Important

January 15, 2014

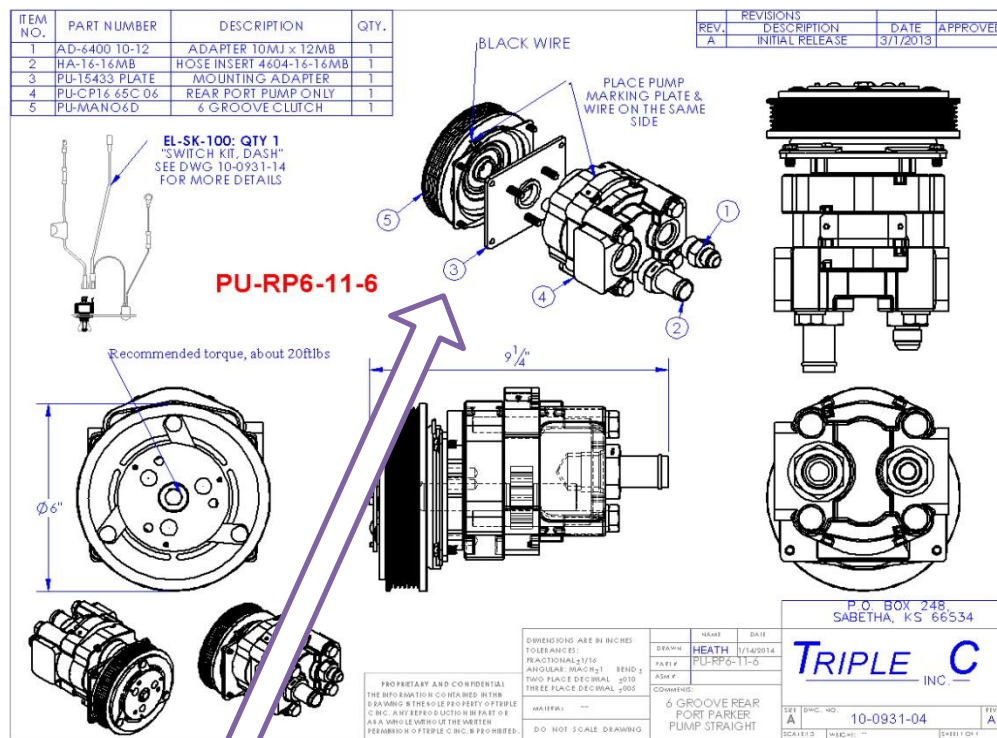
Please replace the three allen socket head cap screws used in mounting the clutch plate with socket button head cap screws 5/16-18 x 1 provided. This will provide adequate clearance between coil and plate on all assemblies. The clutch plate is shown below on item #3.
